VILLEGAS PARK BOXING CENTER
 7240 MARGUERITA AVE.
 RIVERSIDE, CA. 92504

REVISION •
 1-25-02 1st PLAN CHECK REVISIONS
 8-29-02 2nd PLAN CHECK REVISIONS
 9-21-02 ADDENDUM No. 1

DEMOLITION, FLOOR, & REFLEC. CEILING PLANS

A-3

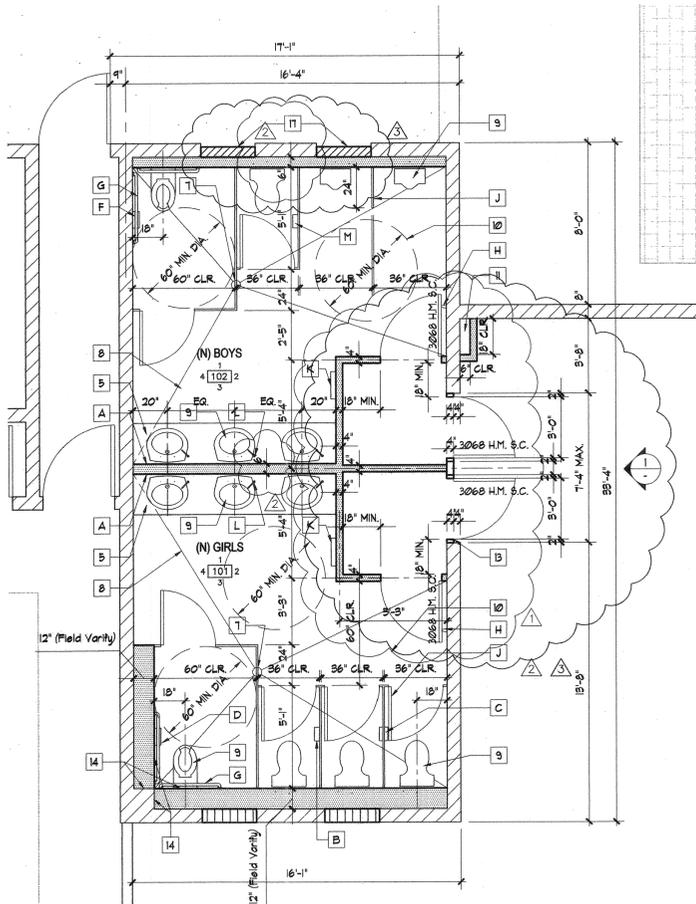
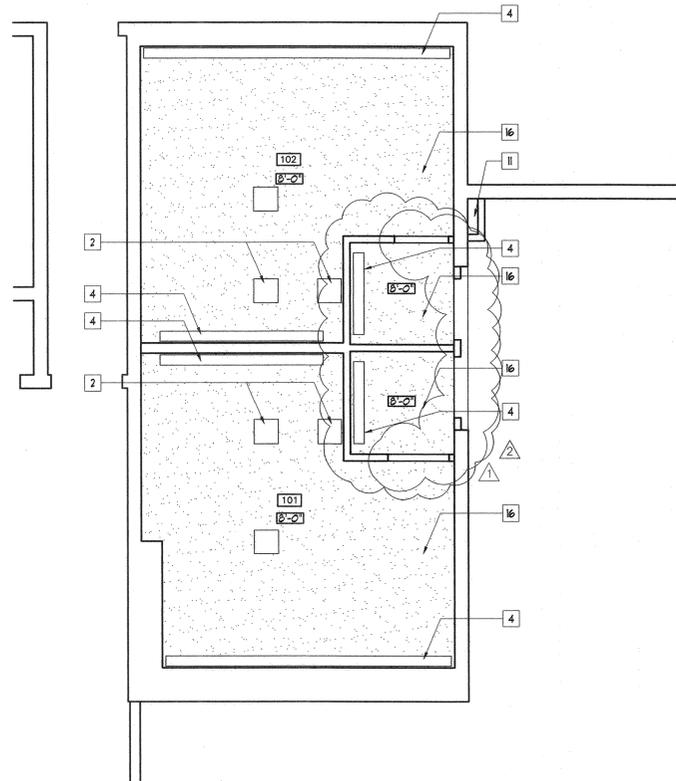
1. Saw-cut and remove existing concrete floor at existing restrooms. Compact the subgrade as required. Construct new 4" thick concrete slab w/ #3 bars each way at 24" O.C. Dowel into existing masonry walls at perimeter at 24" O.C. w/ 18" long #3 bars. Depress slab 2" and slope to drain for the installation. (see plumbing drawings for floor drains). Provide and install ceramic tile floor and base.

2. At new restroom door openings install 2"x4" hollow metal frames to receive solid core doors. Reinforce masonry head above door per structural note. See Saw-cut detail elevation for application. All new door openings to have 2"x4" hollow metal frames with solid core doors.

3. Provide and install 2-1/8" laminated plastic gusset supports at new counters.
4. Toilet accessories for the Boys restroom to be revised for Item 7". Combo Toilet Seat Cover Dispenser & Toilet Tissue Dispenser to be surface mounted in lieu of recessed. (B-4288 and B-4221)

5. Limits of construction and location of construction fencing to be determined at pre-construction meeting.

INTERIOR ELEVATIONS & DETAIL

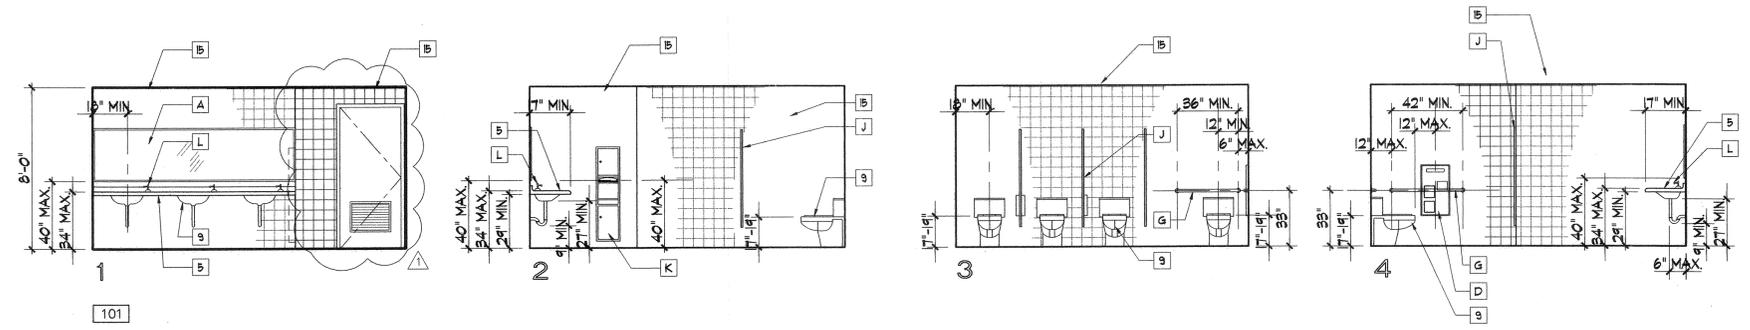
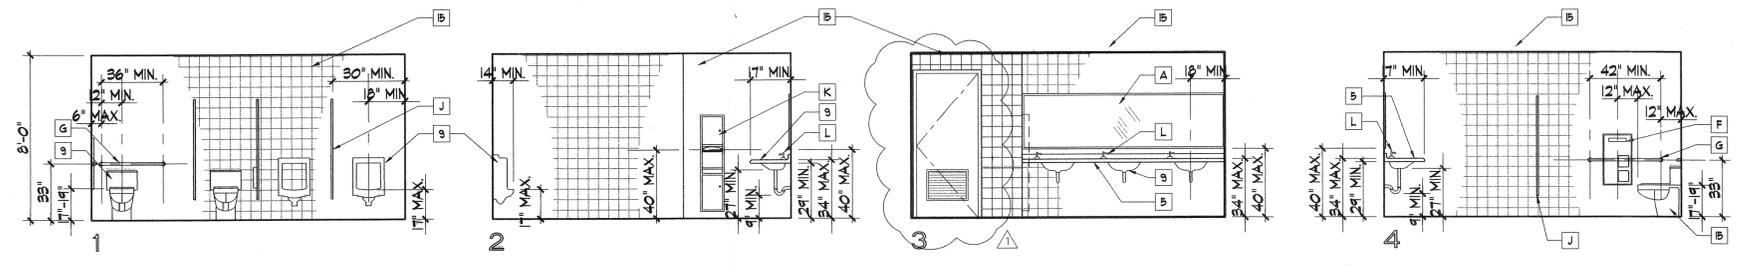
- REVISION NOTES:**
1. Saw-cut and remove existing concrete floor at existing restrooms. Compact the subgrade as required. Construct new 4" thick concrete slab w/ #3 bars each way at 24" O.C. Dowel into existing masonry walls at perimeter at 24" O.C. w/ 18" long #3 bars. Depress slab 2" and slope to drain for tile installation. (see plumbing drawings for floor drains). Provide and install ceramic tile floor and base.

2. All new restroom door openings install 2"x4" hollow metal frames to receive solid core doors. Reinforce masonry head above door per structural note. See Saw-cut detail elevation for application. All new door openings to have 2"x4" hollow metal frames with solid core doors.

3. Provide and install 2-18" laminated plastic gusset supports at new counters.
 4. Toilet accessories for the Boys restroom to be revised for Item "F". Combo Toilet Seat Cover Dispenser & Toilet Tissue Dispenser to be surface mounted in lieu of recessed. (B-4288 and B-4221)
